**As-Built Baseline Monitoring Report**

**GROUNDHOG HOLLOW PROJECT**

NCDMS Project #100049 (Contract #7417) | RFP 16-007277 (Issued 6/21/2017)

RE: Groundhog Hollow Mitigation Site: Baseline Report and As-Built Drawings (NCDMS Project ID #100049)

SHEET NUMBER:  
**S1**

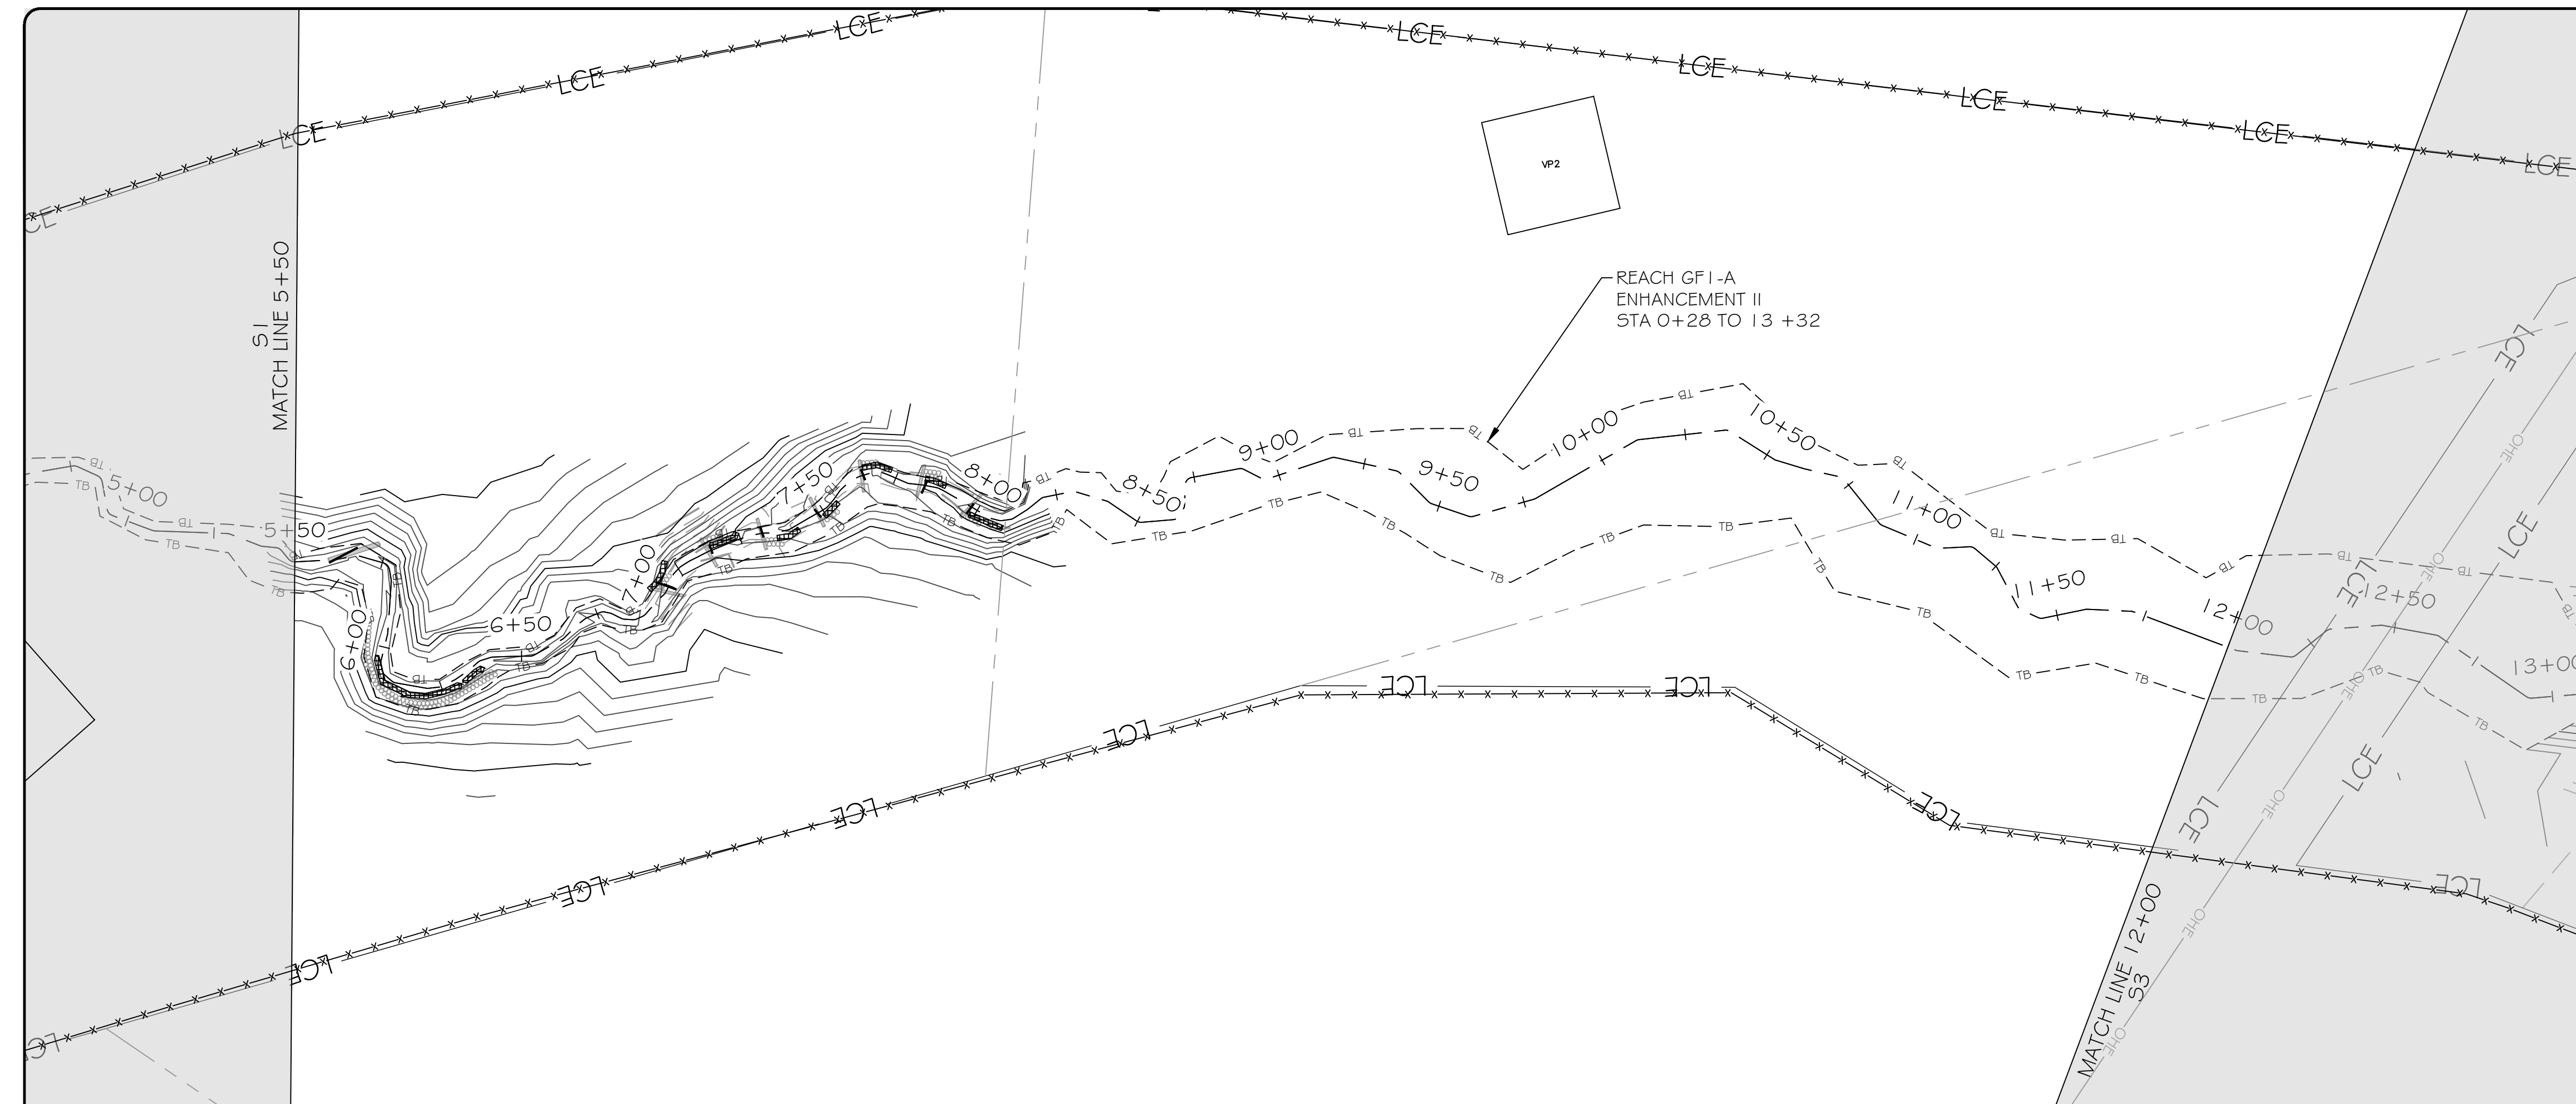
- As noted in the draft MY0 report, please make sure the minor fencing areas currently installed inside of the conservation easement (Sheet 1, Sheet 2, and Sheet 12) are relocated to the recorded conservation easement line or outside of the recorded conservation easement in MY1 (2021). Please document that the fencing relocation was completed in the MY1 (2021) report.

SHEET NUMBER:  
**S6**

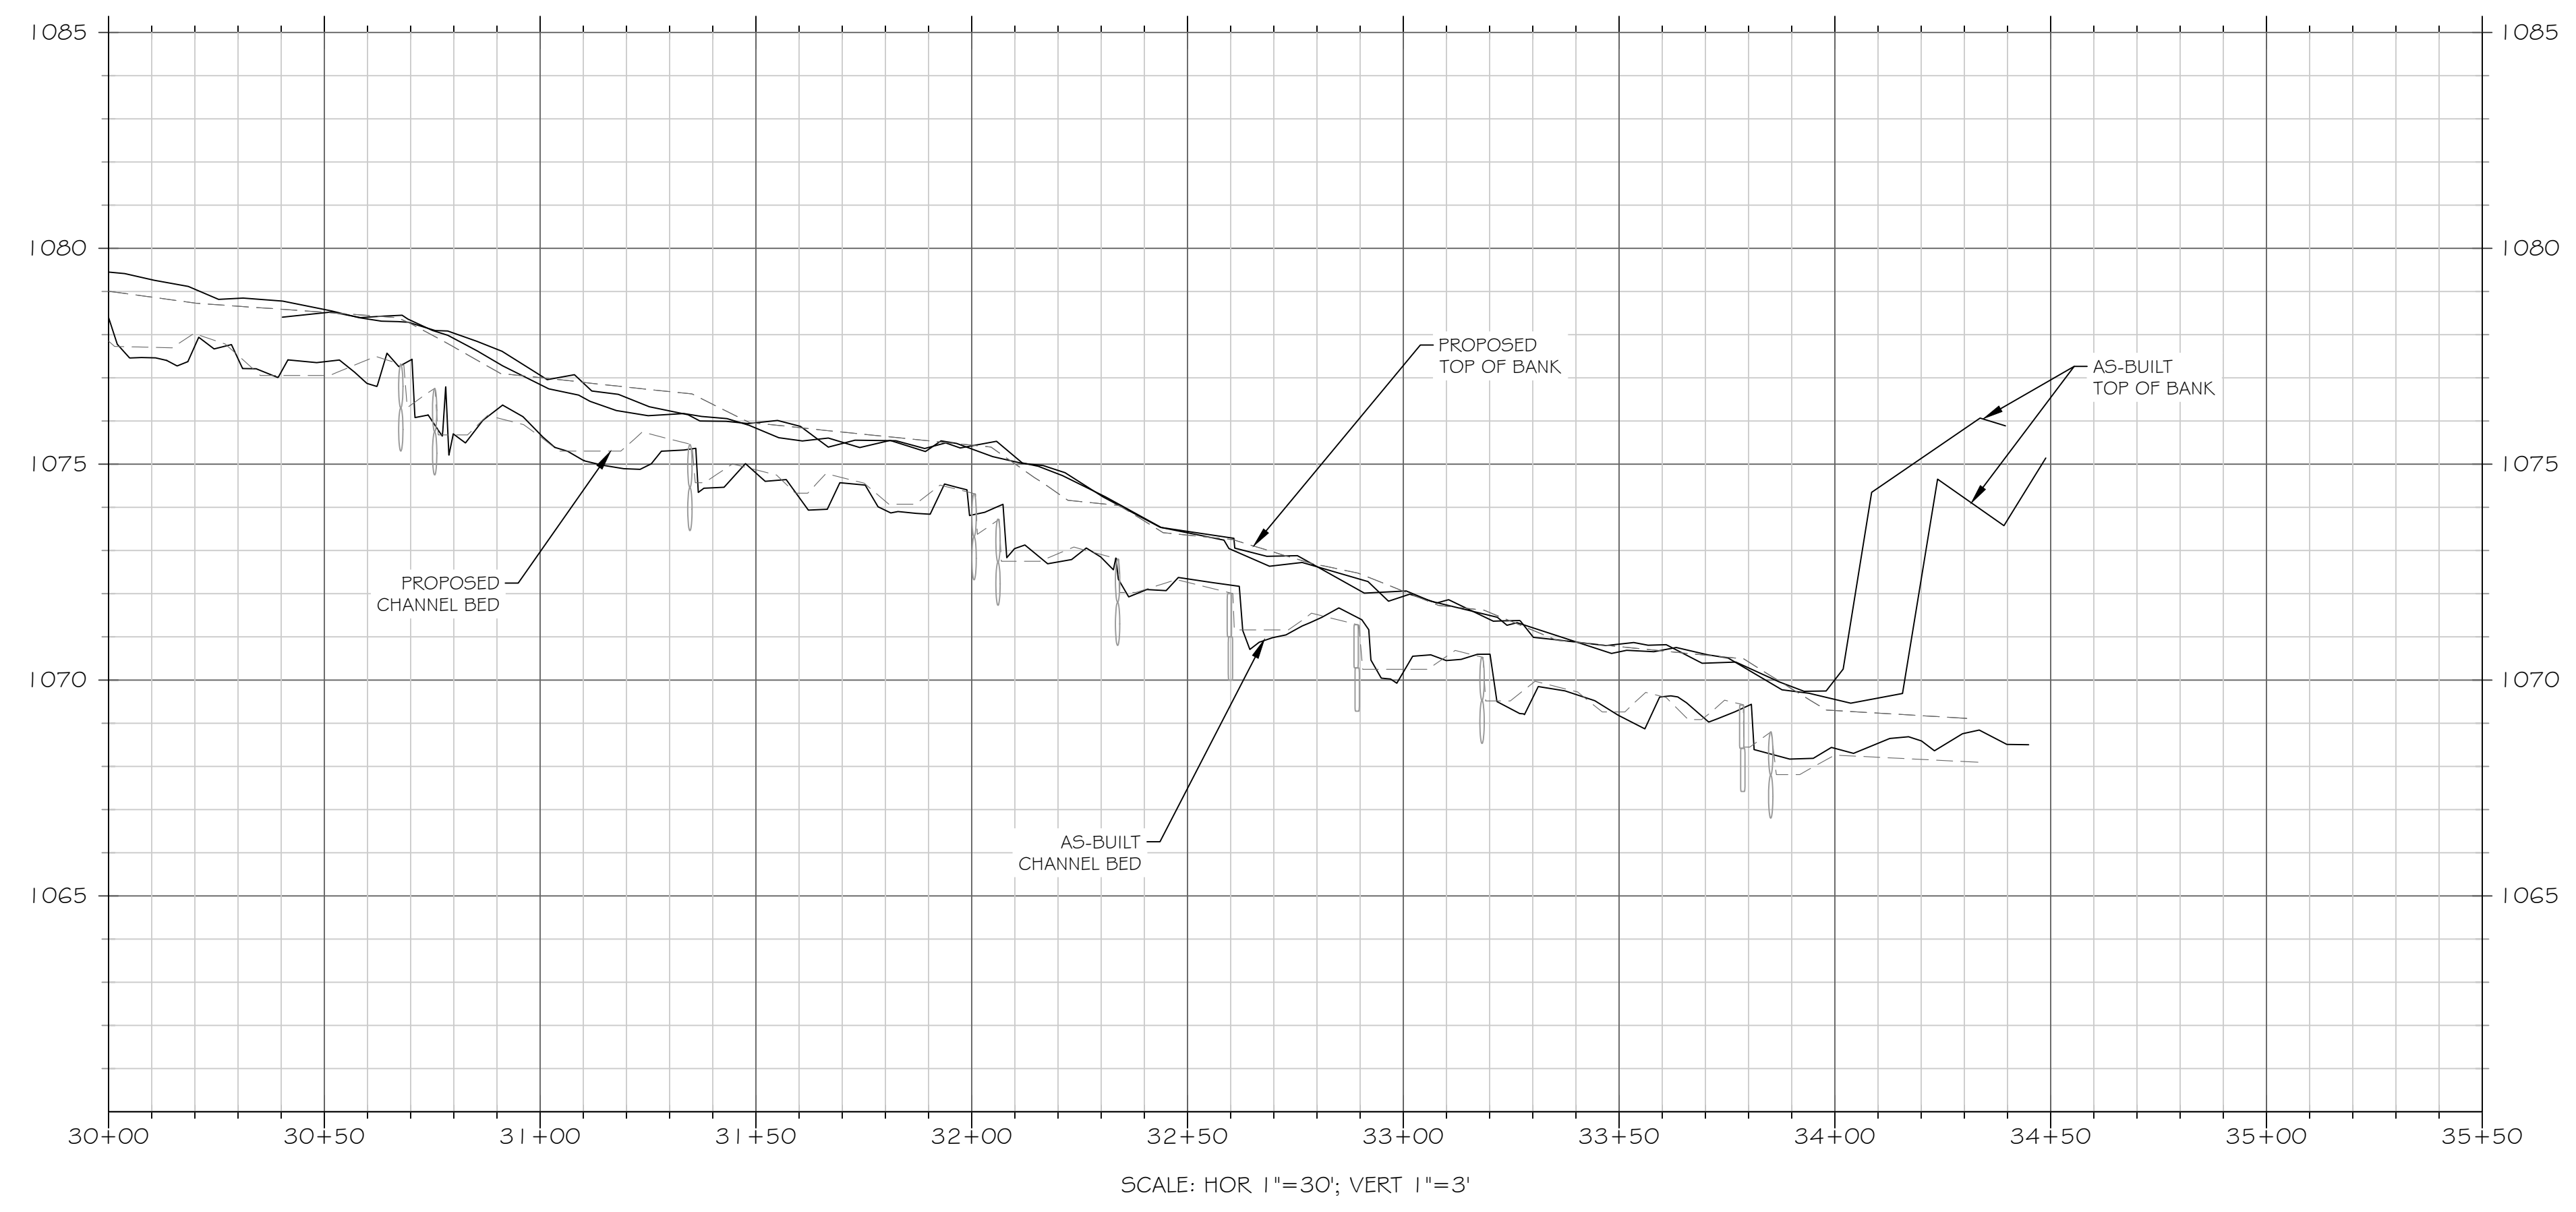
- Sheet 6: The downstream Enhancement (Level 2) portion of GF 1-B is labeled as GF1-C on the record drawings. Please QA/QC and update the report and record drawings so all project reach labeling and stationing is consistent with Table 1 (Mitigation Assets and Components).

Done.
